PPPO-02-10020228-22

**TRANSMITTAL OF THE REVISED 2016 UPDATE OF THE PADUCAH GASEOUS
DIFFUSION PLANT SITEWIDE GROUNDWATER FLOW MODEL,
DOE/LX/07-2415&D2/A1**

**2016 Update
of the Paducah Gaseous Diffusion Plant
Sitewide Groundwater Flow Model**

Date Issued—June 2022

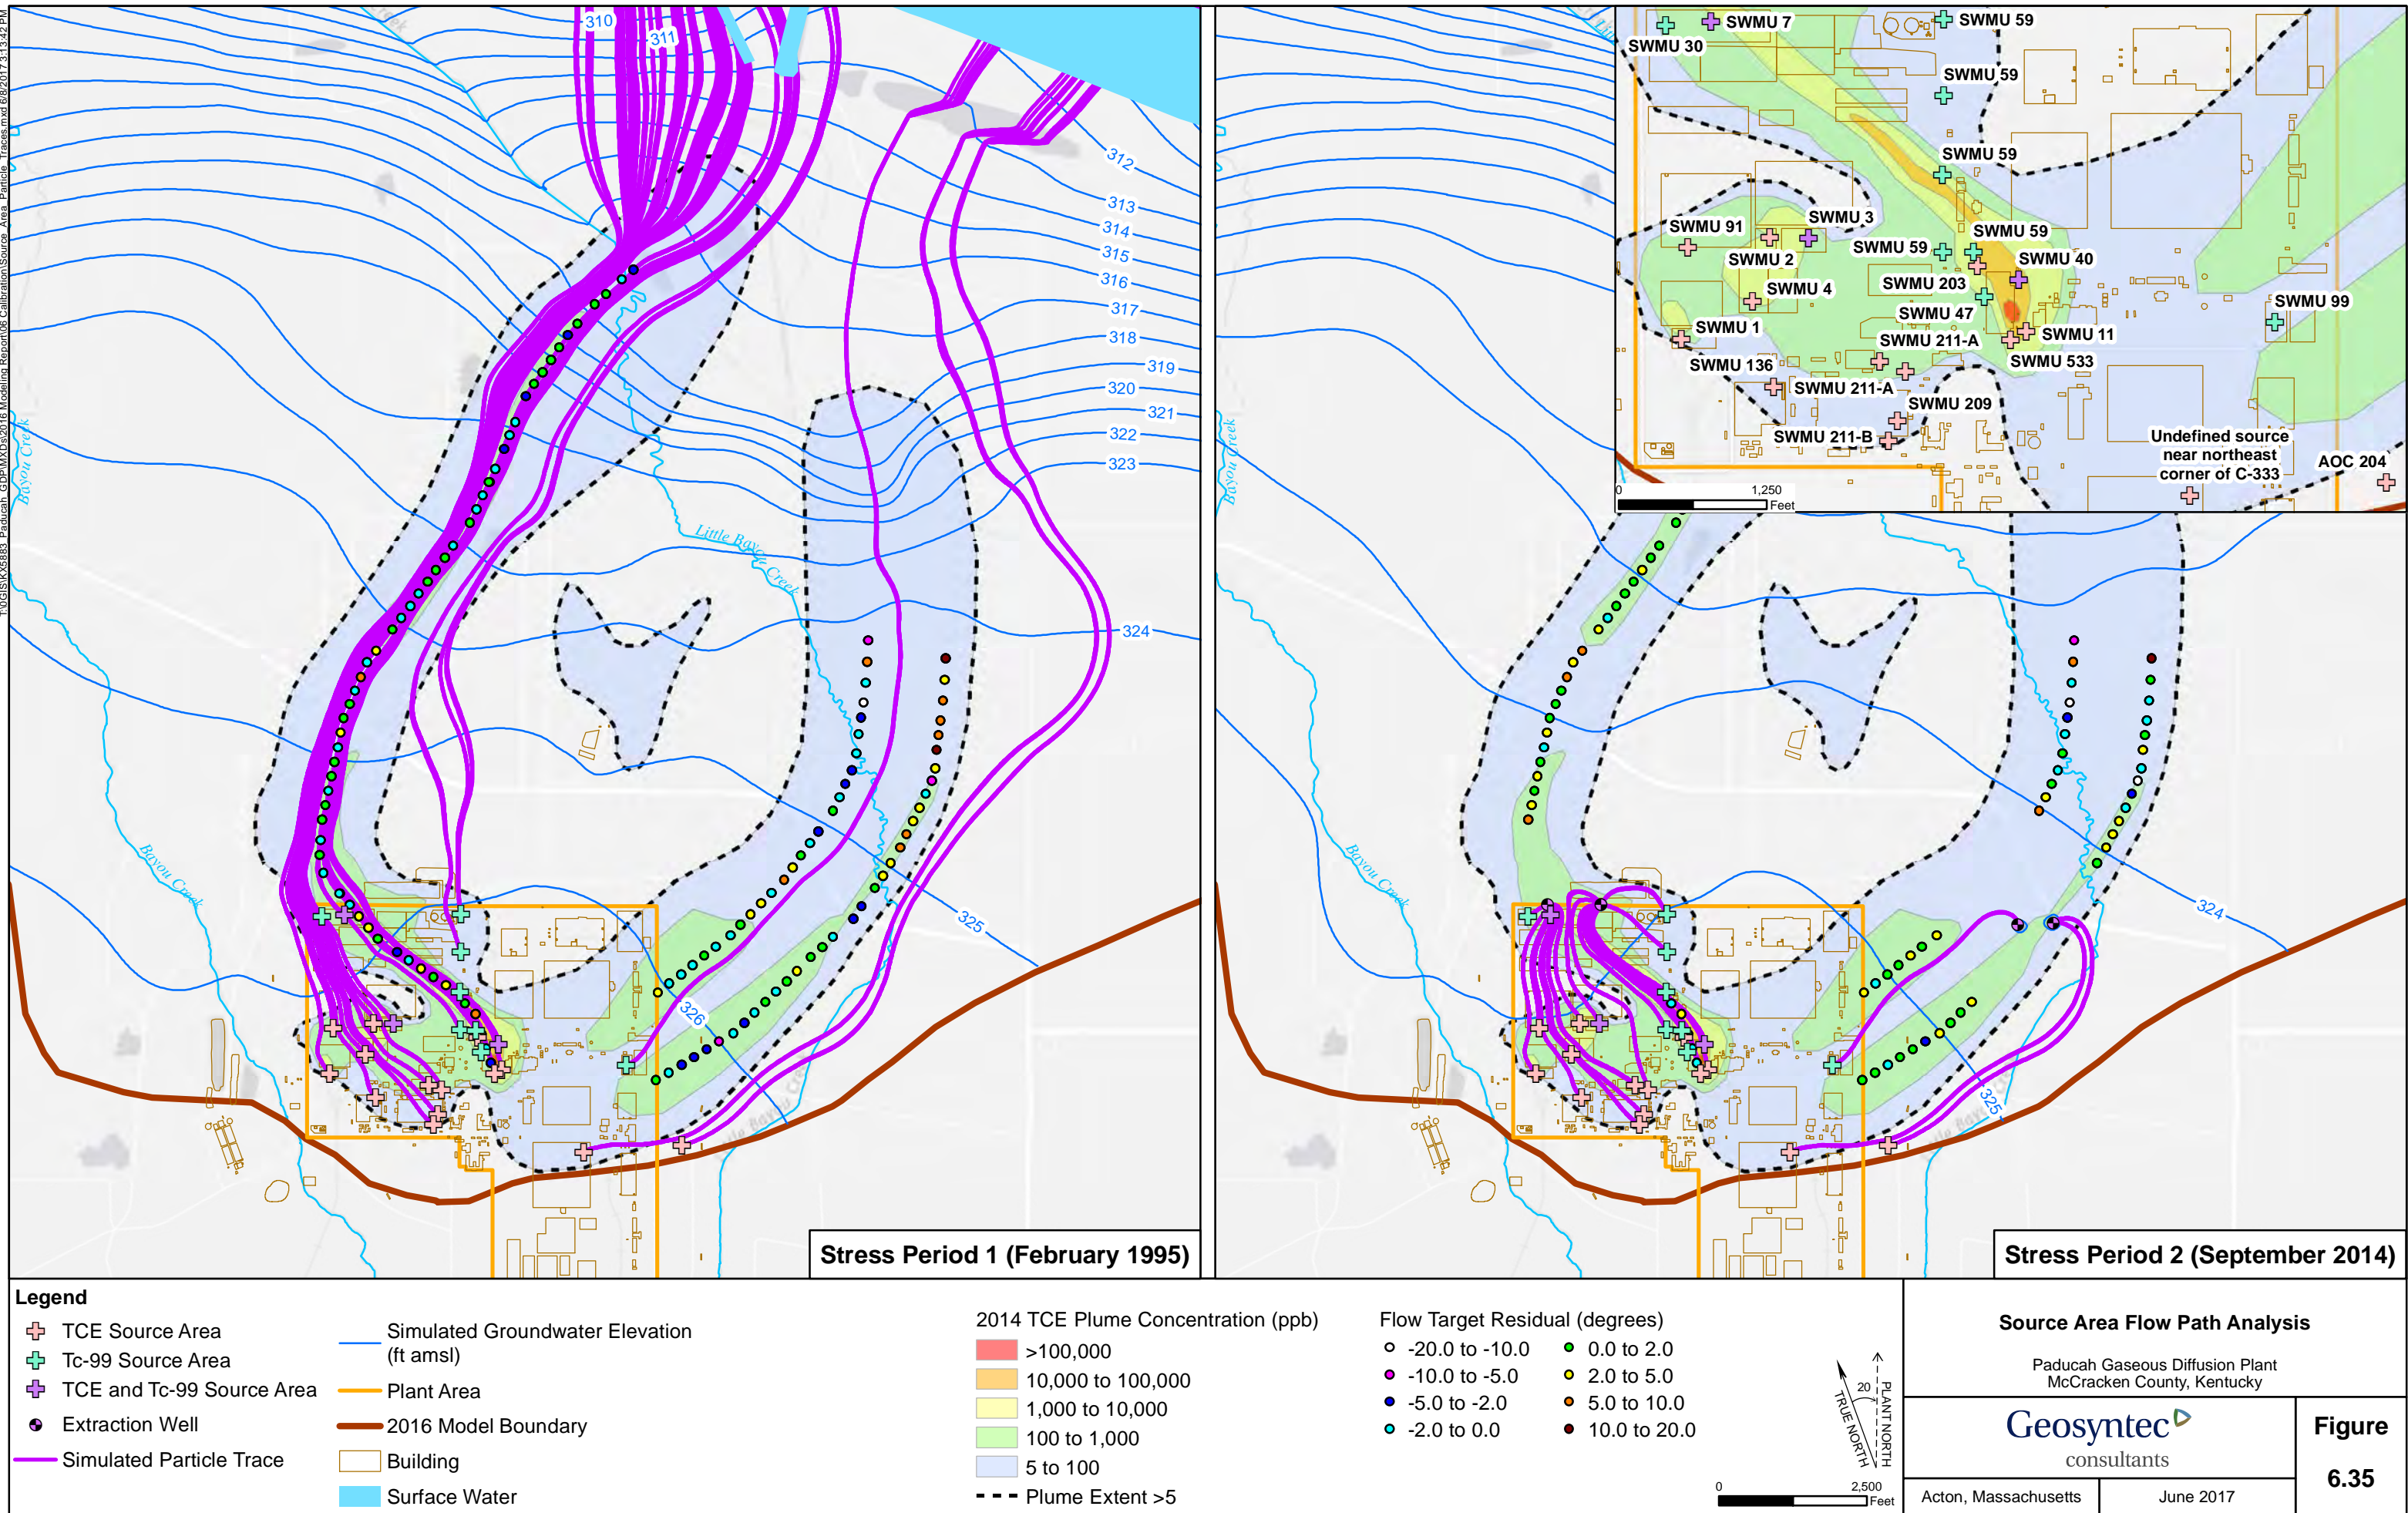
4. The implications of Comments 2 and 3 are evident from Figure 6.35 (attached), where it shows that the extraction wells are capturing particles from all the source locations within the plant area. Since the higher transmissivity channels have been created along the flow path towards the extraction wells, all the particles are ending up in the extraction wells. If this has been true, any release of contaminants anywhere within the plant boundary would most likely be captured by these extraction wells. EPA is not aware of any validation data available to support his modeling result. This is a significant line of evidence for why it is not reasonable to accept the results from the current version of the model for use in CERCLA cleanup activities under the PGDP FFA.
